**FORT BEND COUNTY
ENGINEERING**

**CHANGE
ORDER**

PROJECT:
Bellaire Blvd. from FM 1464 to San Pablo Drive
Paving and Drainage Improvements.

CHANGE ORDER NUMBER 03
DATE 2/9/2018
PROJECT NUMBER 13202
CONTRACT FOR 3,772,635.08
CONTRACT DATE 3/28/2017
FBC PURCHASE ORDER NO 151499

PROPOSED TYPICAL ROADWAY SECTION
STATION 374+20
NTS

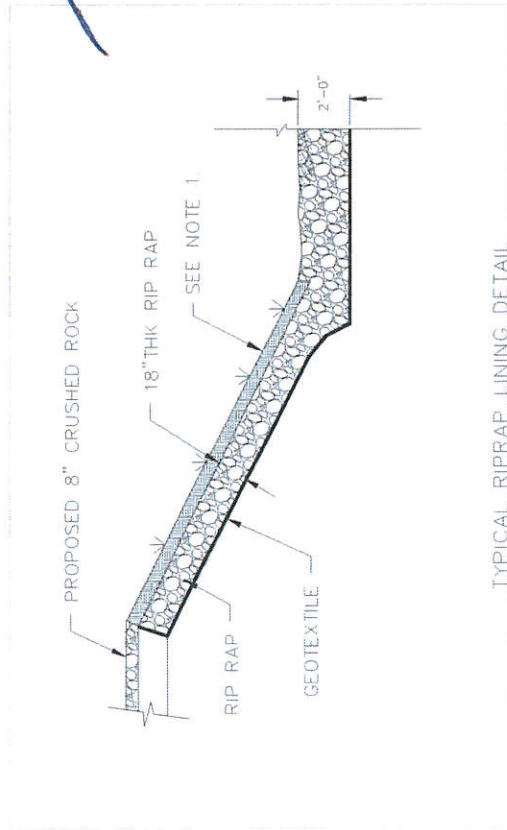
The purpose of this document is to confirm the price requested for the new item of a slope intercept for a 30" CMP at appx. STA 37+75 RT 75.00. Per plans provided on 2/7/2018.

- Qty 1- Slope intercept for 30" CMP – Price \$2,500.00 EA

*RIPRAP & GEOTEXTILE
IS NOT PART OF THIS
CHANGE. P.B.*
